**Re: Minor Project Refinement No. 12 for the TL 6975 San Marcos to Escondido Project**

**ATTACHMENT A**  
**MPR-12 Form**

## TL6975 San Marcos to Escondido 69 kV Project CPUC Minor Project Refinement Form

**TL6975 SAN MARCOS  
to ESCONDIDO PROJECT**  
**MPR 12**  
**Additional Work Areas**  
**San Diego County, CA**

**ATTACHMENT B**  
**MPR-12 Figure**

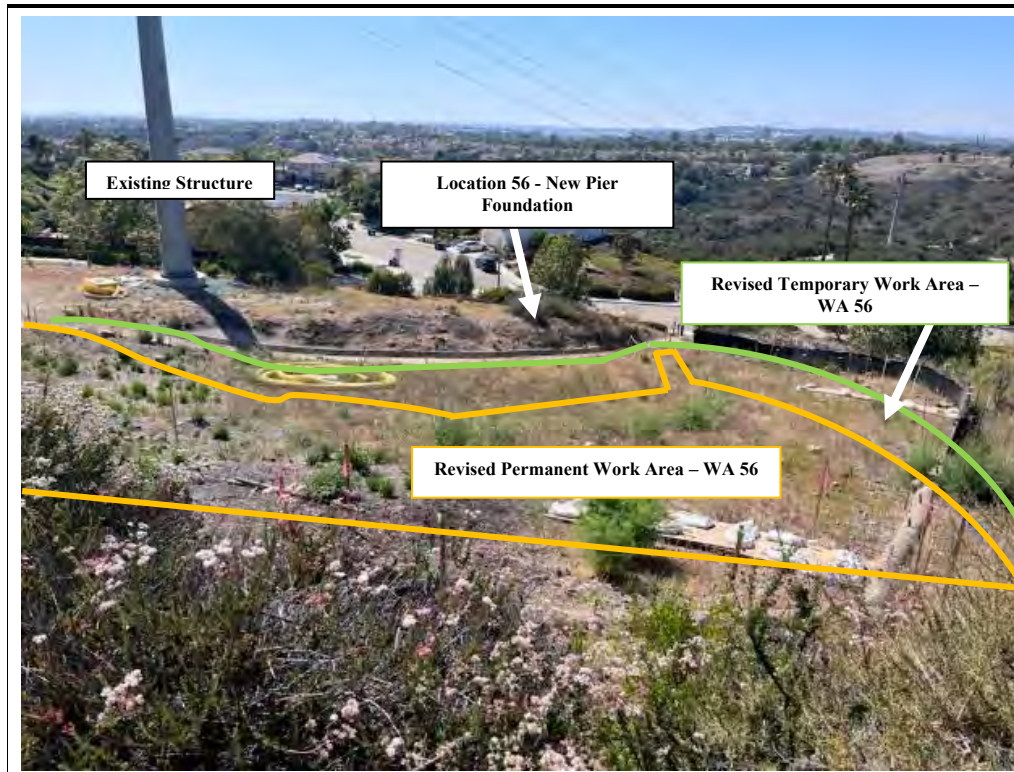
- **Location 56 Revised Work Area (WA 56)<sup>1</sup>:** WA 56 is the revised work pad east of Location 56 which has been shifted approximately 20 feet west. This work area revision prompted the need for a retaining wall to be built within the permanent pad as shown on **Attachment B**. The retaining wall will be approximately 8 feet high and 60 feet long. There is no other change to the approved scope of work at this location, which will include grading the permanent pad and the installation of a brow ditch.

- **WA 56:** During field review it was determined that the approved work area for the permanent pad at Location 56 was partially within the Carlsbad Municipal Water District's easement and needed to be shifted approximately 20 feet west to avoid the easement. This shift prompted the need for a retaining wall to be installed to stabilize the slope of the pad. The revised work limits of the pad are within the SDG&E ROW. It should be noted, taking into account the existing work areas that will no longer be used by the Project, there will be a net decrease of overall work area (-630 sf, 0.01 acre) resulting from this change as demonstrated in the Disturbance Acreage Changes Section below.
